LOCATION: Prairie Creek Road, west of Clearfield Road

REQUEST: An application to create one 2.214-acre (96,454-square foot) lot from a tract of land in City Block 7845 on property located on Prairie Creek Road, west of Clearfield Road.

Case no: **S234-121**

EXISTING AREA ANALYSIS MAP

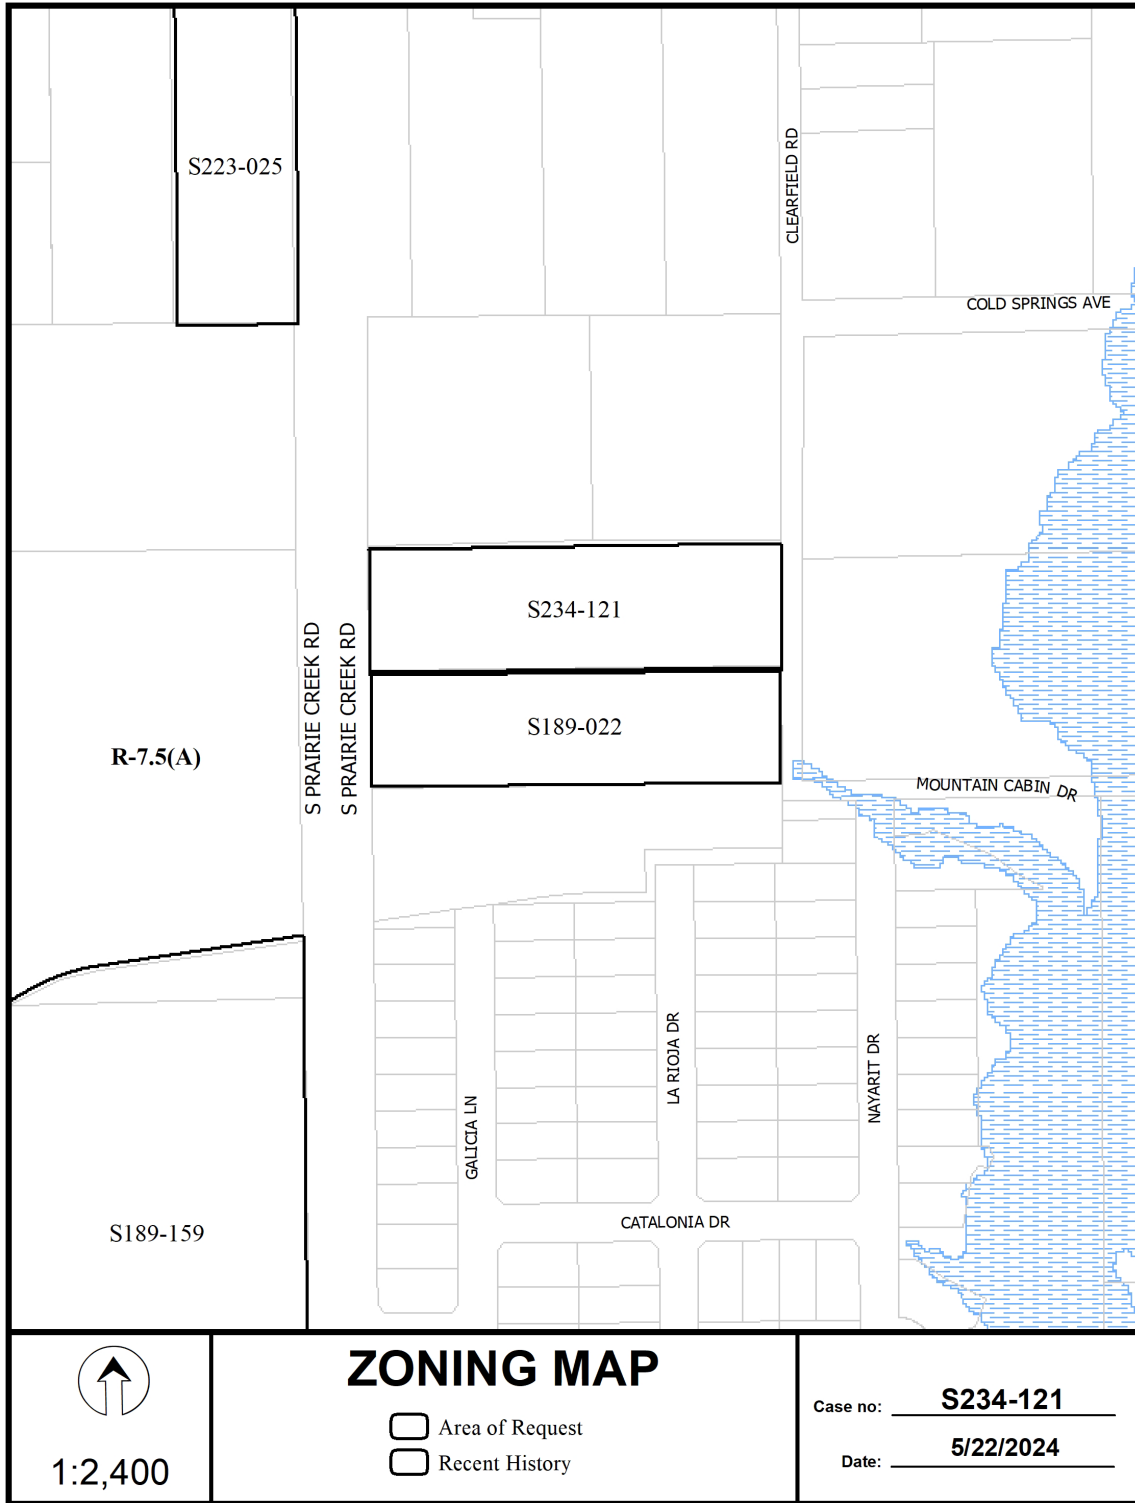
- The lots are being created from a tract of land; therefore, it does not qualify for a residential replat and can be approved on the consent agenda.
- The properties to the immediate vicinity of the request have lot widths ranging in size from 48 feet 526 feet and lot areas ranging in size from 5,464 square feet to 296,482 square feet and are zoned R-7.5(A) Single Family District. (*Refer to the existing area analysis map*)
